Recall Bulletin

PRODUCT SAFETY RECALL

SUBJECT: Positive Battery Cable Routing - Reroute

MODELS: 2010 Chevrolet Camaro
Equipped with a V8 Engine

2271930

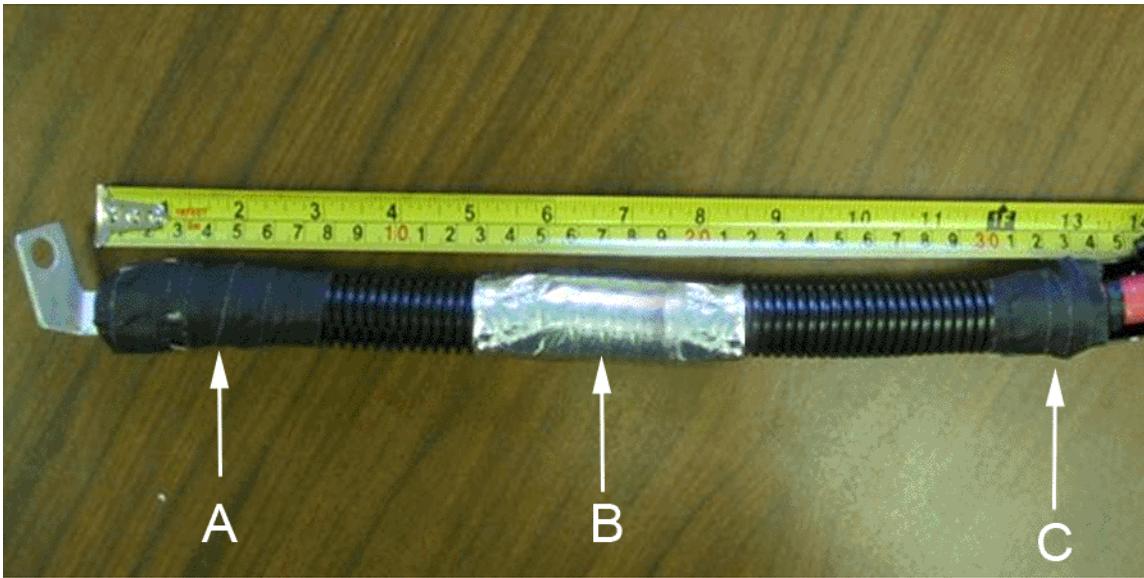
- (1) Battery Positive Starter Cable-to-Starter Contact Area
- (2) Motor Mount-to-Battery Positive Starter Cable Contact Area
- (3) Battery Positive Starter Cable
- (4) Starter
- (5) Motor Mount

4. Locate where the battery positive starter cable (3) contacts the starter (4) and motor mount (5). Refer to the illustration above.
5. Remove starter terminal nut and the battery starter cable from the starter terminal.
6. Move the battery starter cable away from the motor mount.

7. Use a hand file to round the edge of the motor mount (5) in the battery positive starter cable-to-motor mount contact area.

2272624

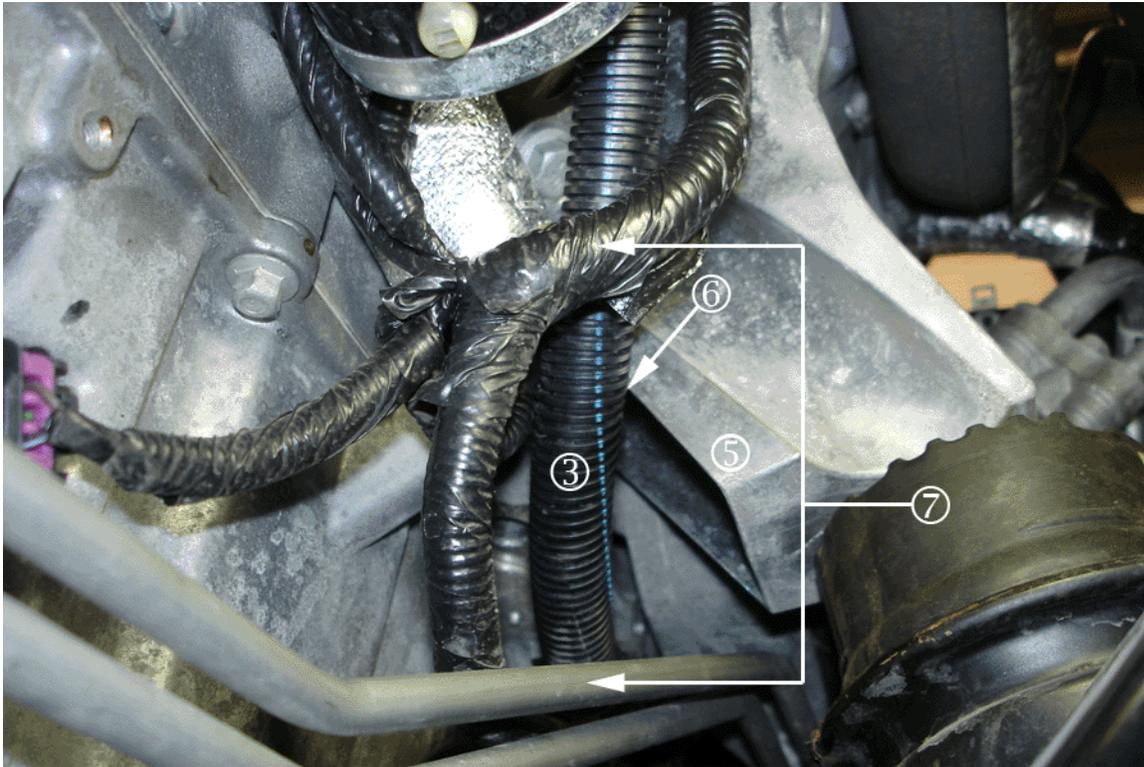
Caution: To avoid battery positive starter cable damage, wrap the battery positive starter cable with the protective tapes specified in this bulletin. Do NOT use any other tape to complete the repair.

9. Pull the conduit forward to the terminal and tape it in place using Elliott EG190 tape (P/N 19117900 or 19117901 to be available in the future).
 - 9.1 Secure the conduit to the battery positive starter terminal with Elliott EG190 tape (P/N 19117900 or 19117901 to be available in the future).
 - 9.2 Begin wrapping the tape at the terminal end of the battery positive starter cable and continue wrapping the tape 76 mm (3 in) forward toward the front of the vehicle.
 - 9.3 Wrap the Elliott EG190 tape (P/N 19117900 or 19117901 to be available in the future) around the battery positive starter cable in the specified 76 mm (3 in) section of the cable (A) four times at 50 percent overlap.
 - 9.4 Wrap the other end of the conduit that is forward of the motor mount (C) with the Elliott EG190 tape (P/N 19117900 or 19117901 to be available in the future) to secure the conduit to the channel.
